Amendments to the Drawings:

Attachment: Replacement Sheet (1)
Annotated Sheet Showing Changes (1)

FIG. 2

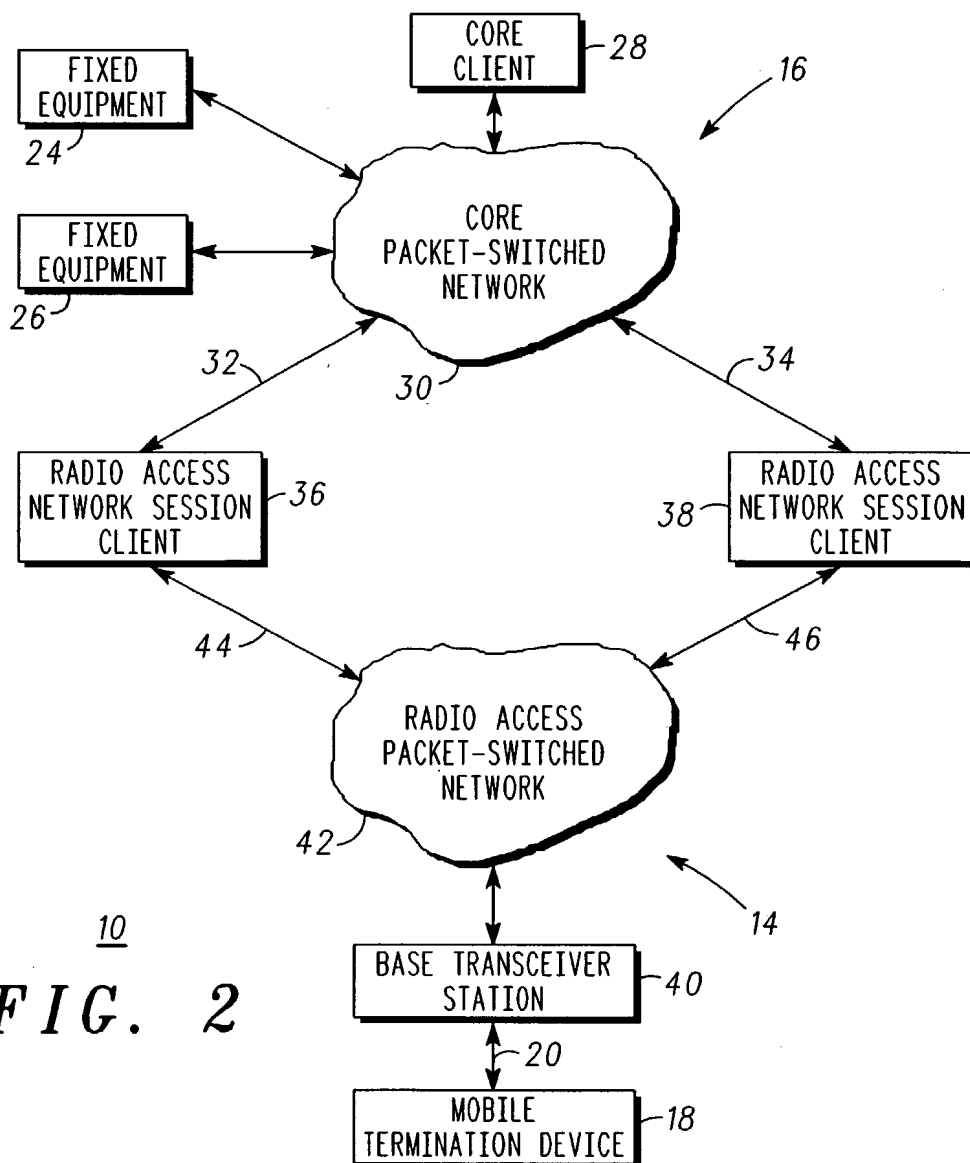
The attached one (1) page of replacement sheet of drawings includes changes to FIG. 2. This replacement drawing sheet, which includes FIGs. 1 and 2, replaces the original drawing sheet including FIGs. 1 and 2. Specifically, in FIG. 2, the text at element 38 has been changed from “access network radio session client” to --radio access network session client--. Support for this change can be found in the specification at, for example, page 3, lines 1-4 (providing that “RSC” stands for radio access network session client) and page 6, lines 24-29 (identifying element 38 as an “RSC”). Consequently, no new matter has been added by this change.
